RE: NOTIFICATION OF WETLANDS PROTECTION ACT FILE NUMBER

This project has been assigned the following file # : WE 229-0274

**RE: Notification of Wetlands Protection Act File No. WE 229-0274
Accessory Dwelling Unit
9 Randall Road, Montague MA**

From: [Jesse A. Harris](#)
To: [Maureen Pollock](#)
Cc: [Melissa Kaplan](#)
Subject: 9 Randall Road - Updated Plans
Date: Wednesday, September 9, 2026 9:52:34 AM
Attachments: [2026-09-09 Revised Site Preparation Plan SHT 3 OF 6.pdf](#)
[2026-09-09 Revised Details SHT 6 OF 6.pdf](#)

SITE PREPARATION PLAN

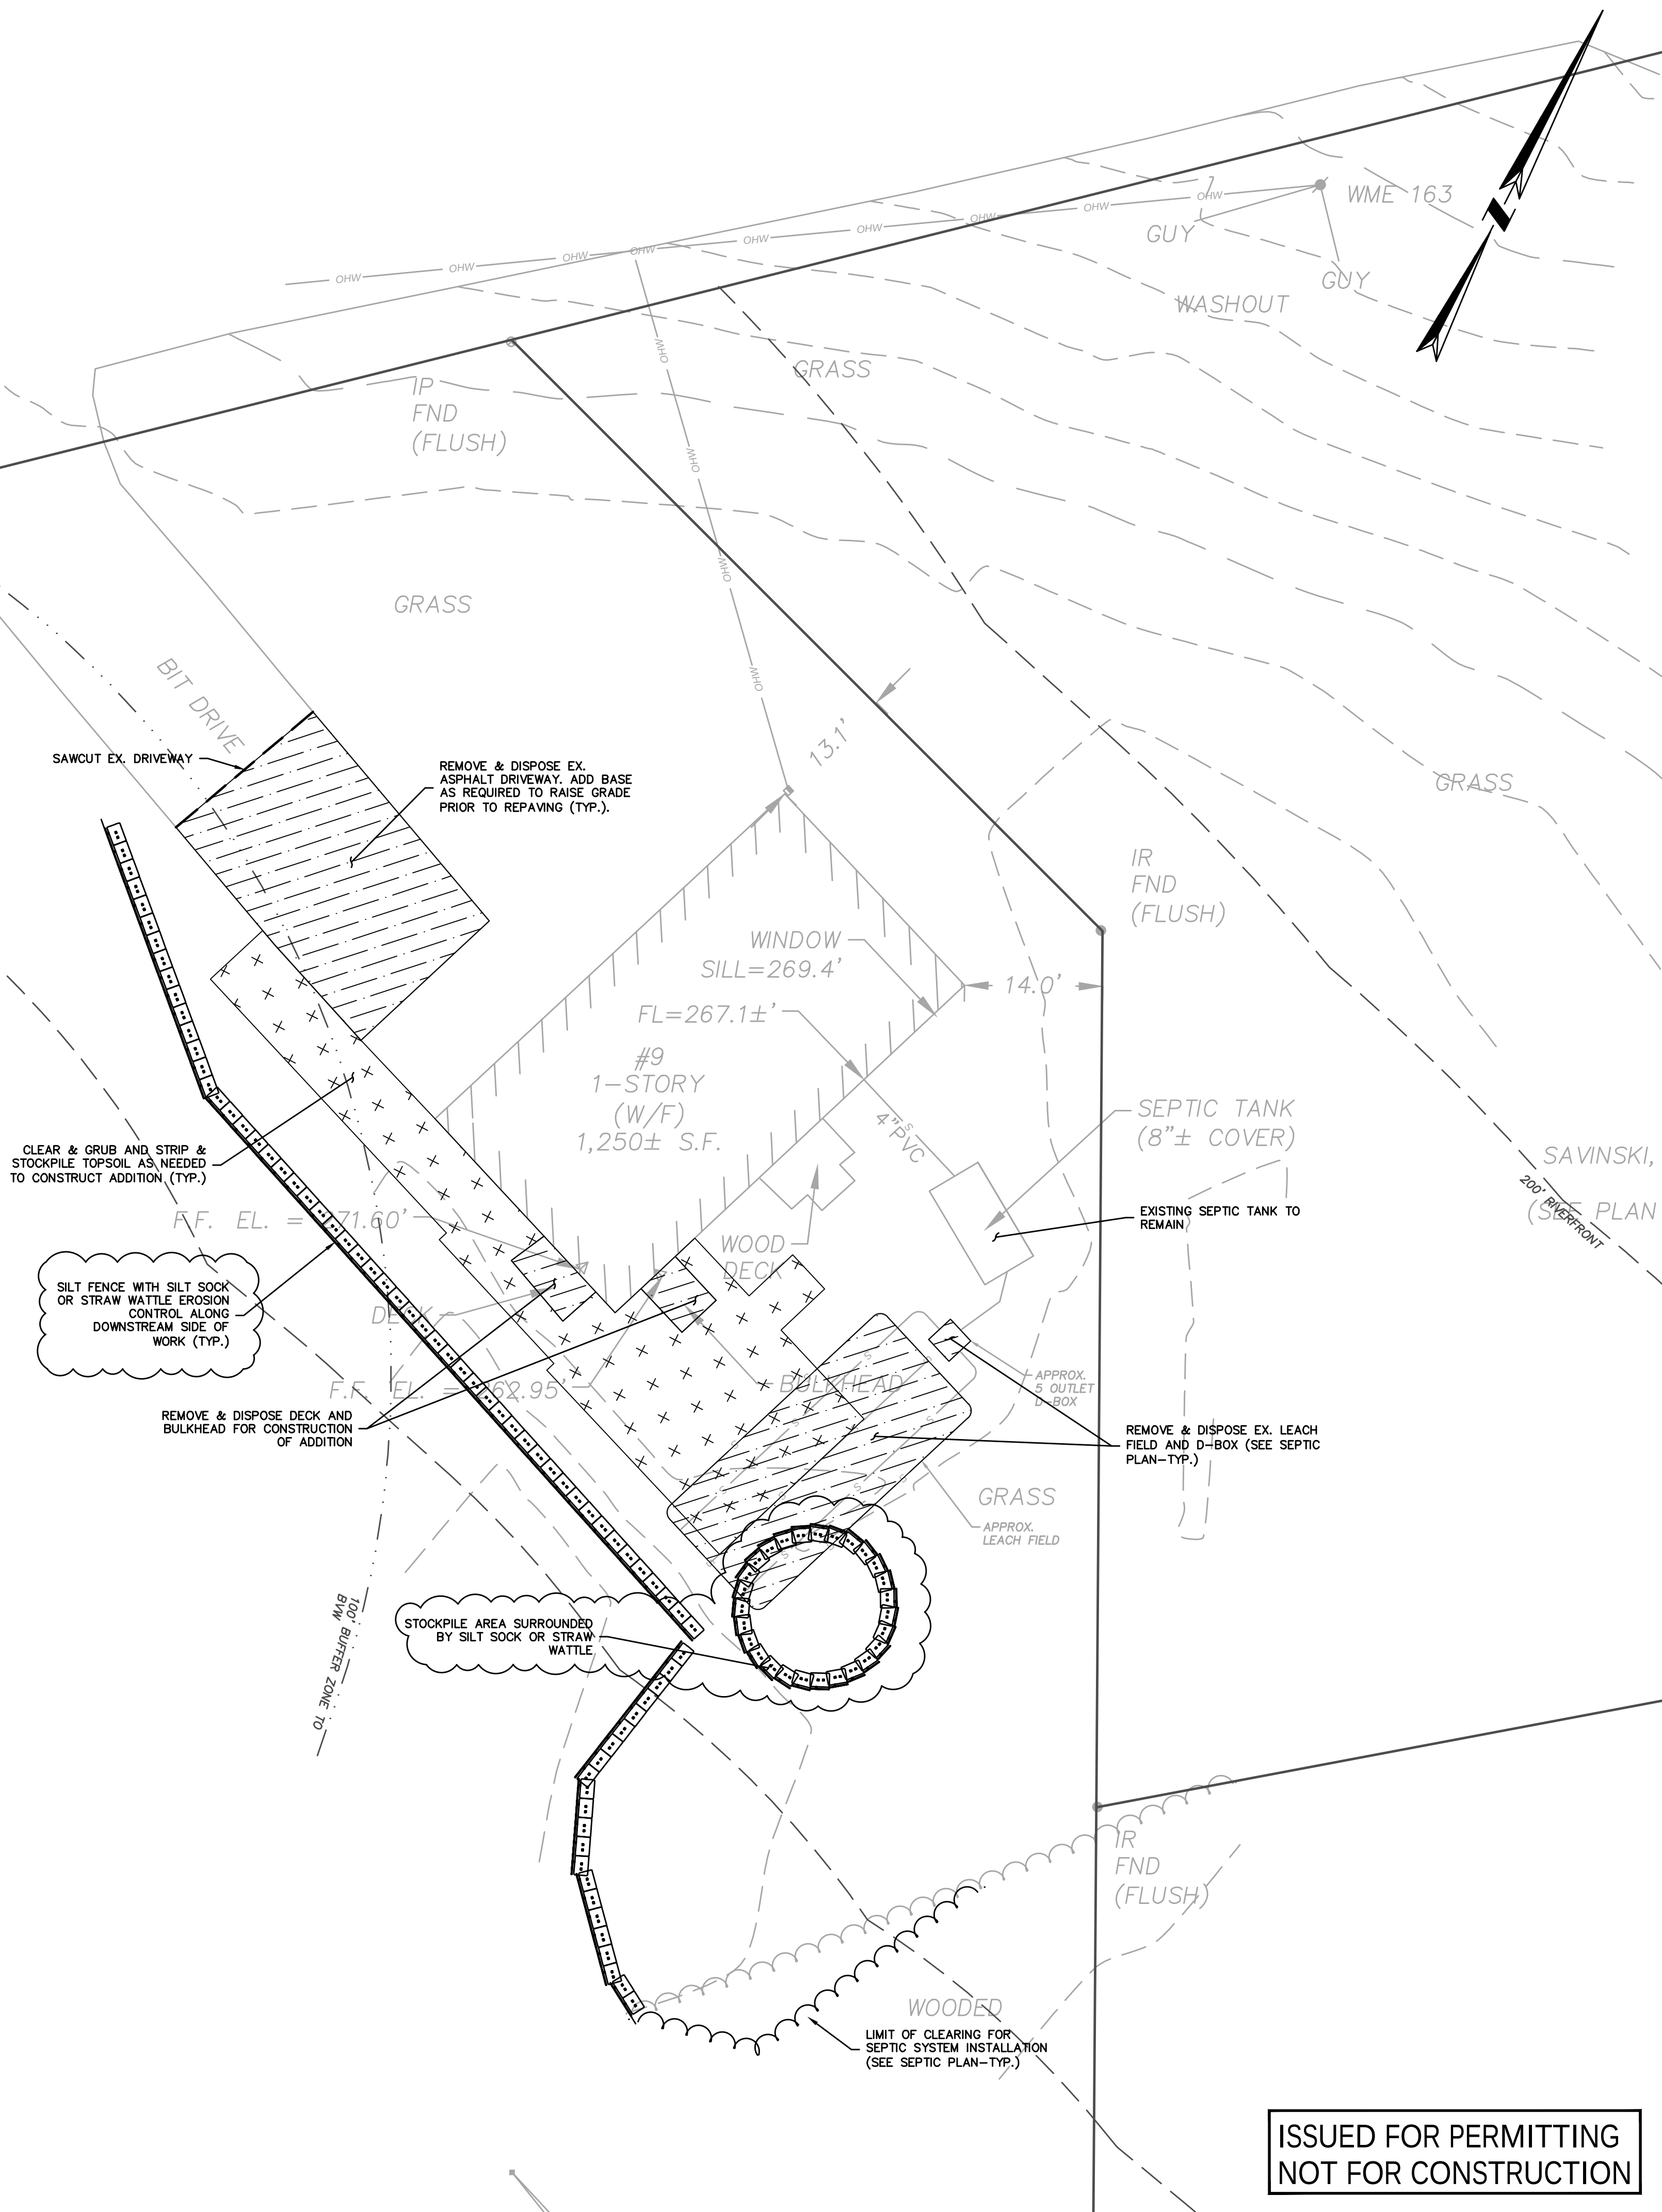
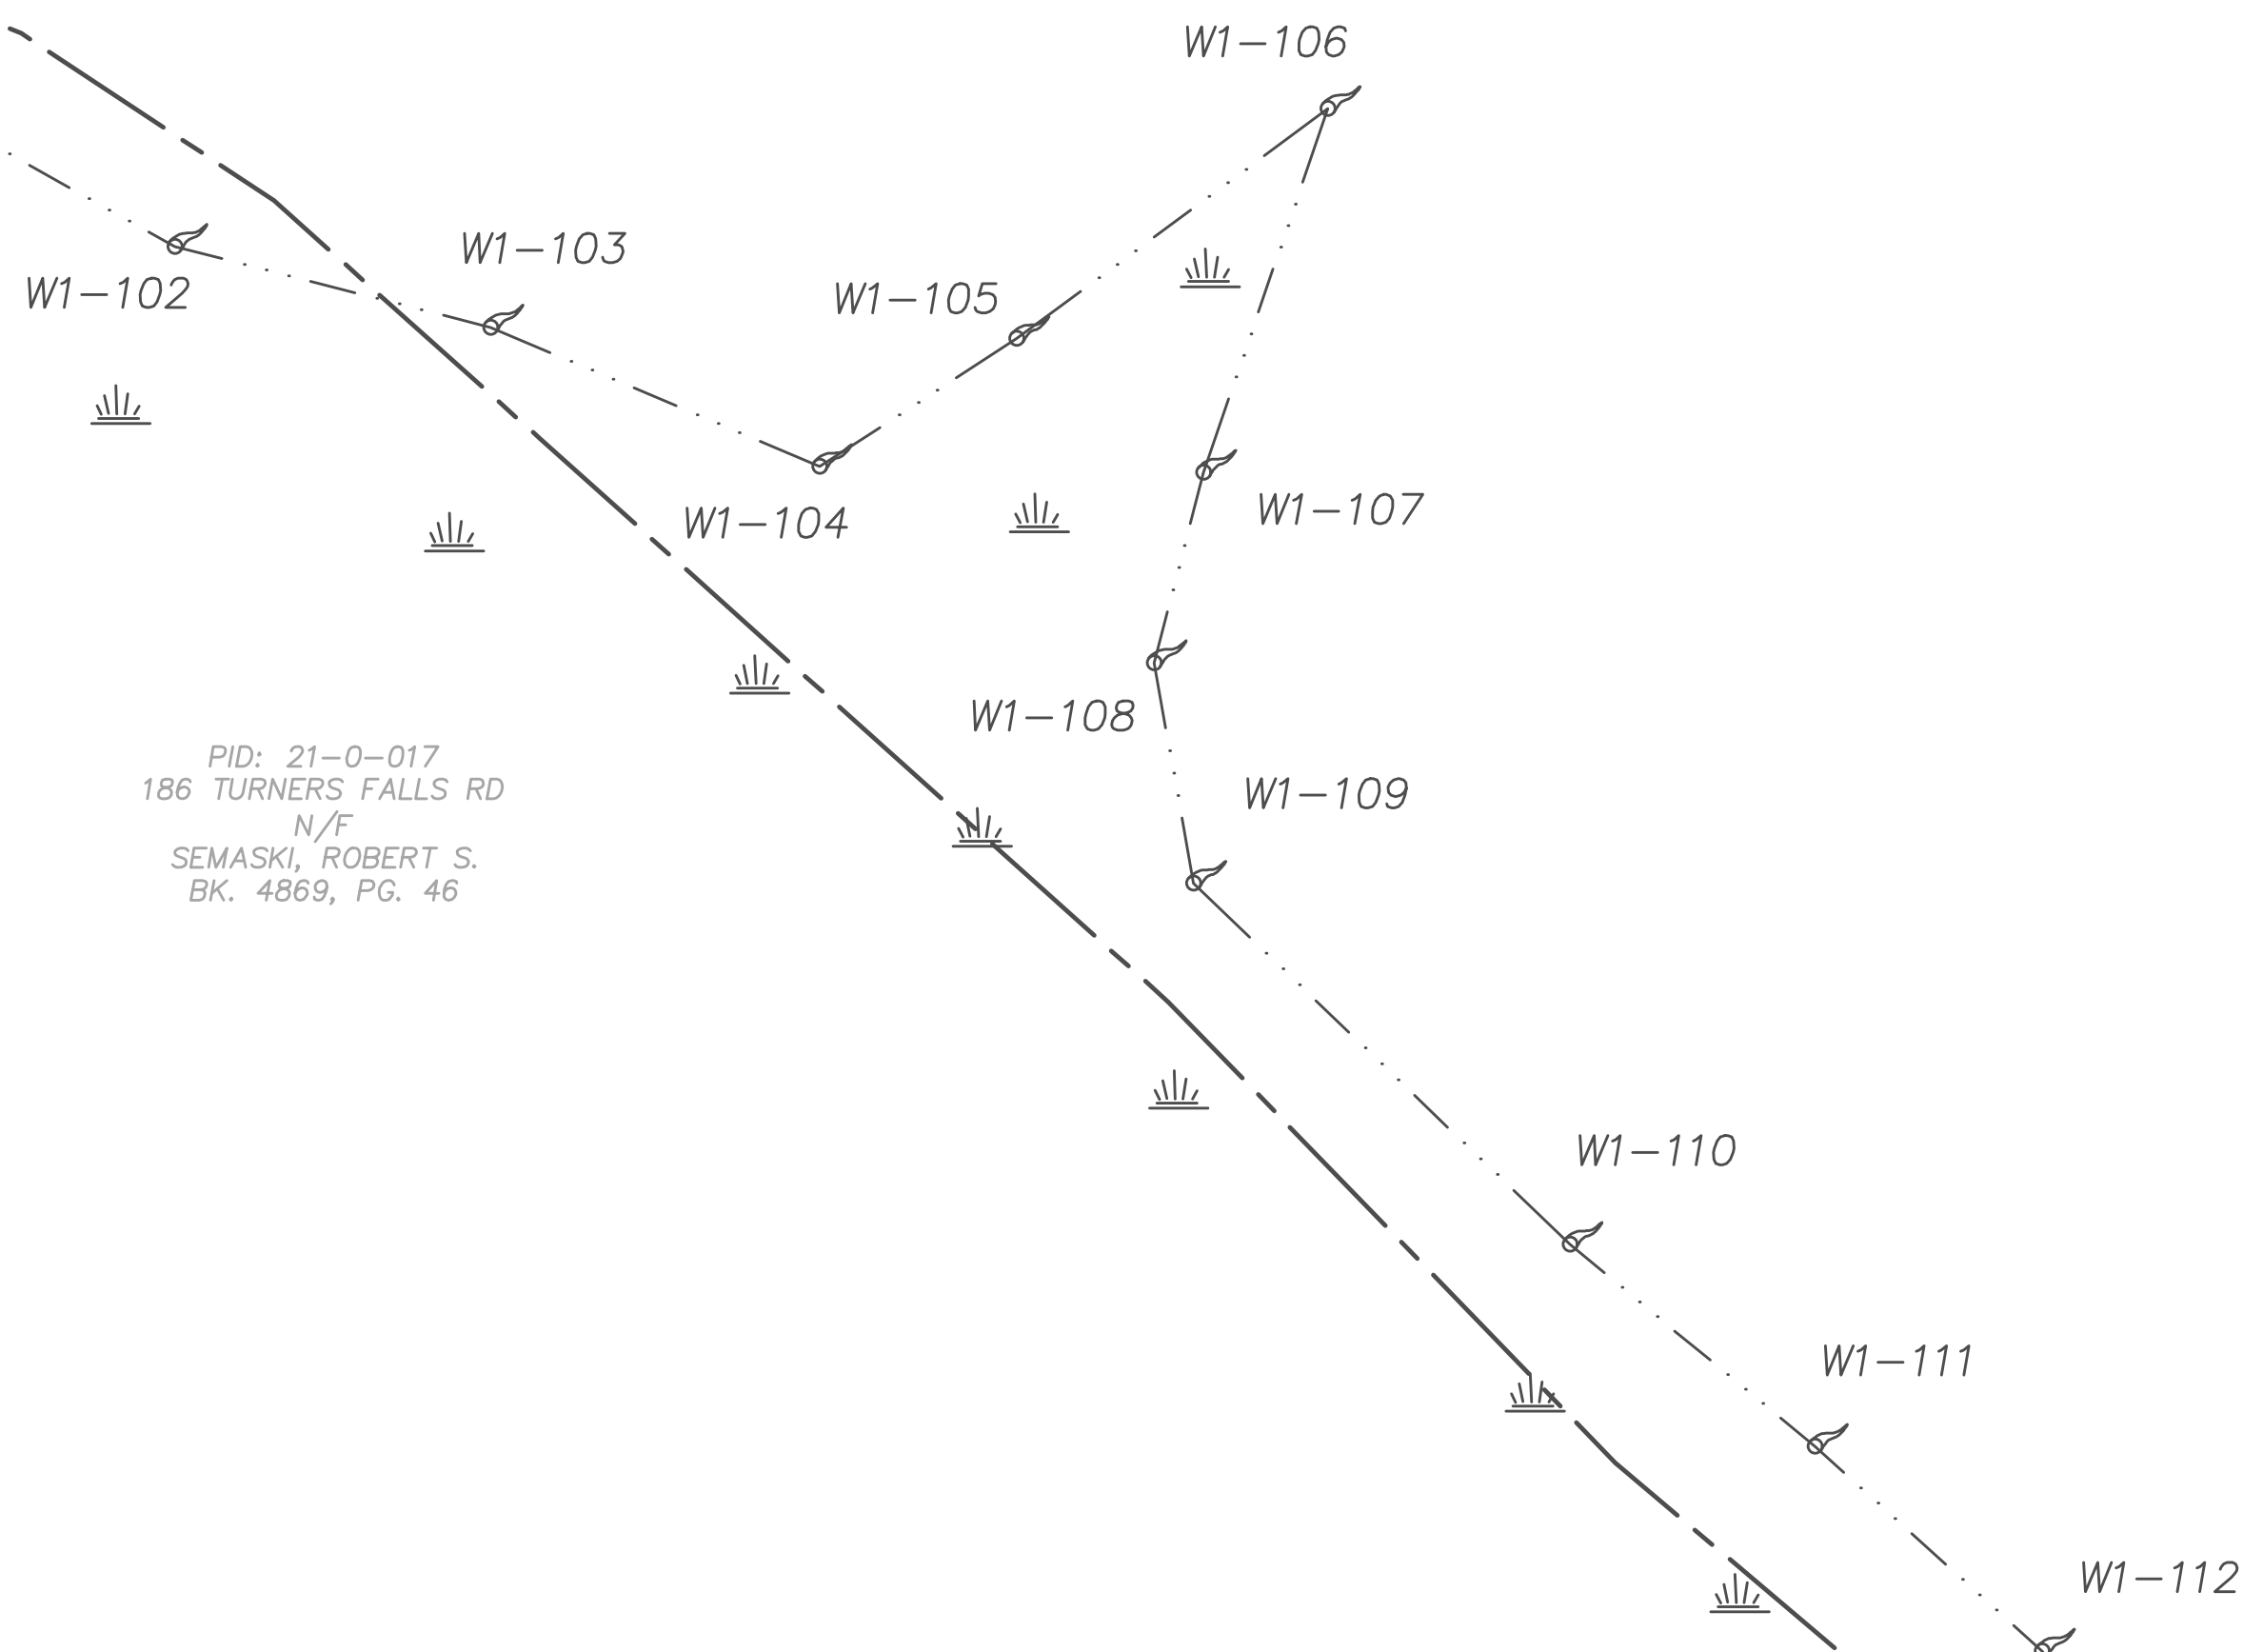
Please find attached the revised site preparation plan, which includes silt fence in addition to straw wattle, as well as a possible stockpile location with E&S controls, as discussed during yesterday's ConnComm site walk. Also attached is the revised detail sheet incorporating the silt fence.

NO.	DATE	DESC.
1	09/09/26	ADDED E&S CONTROLS
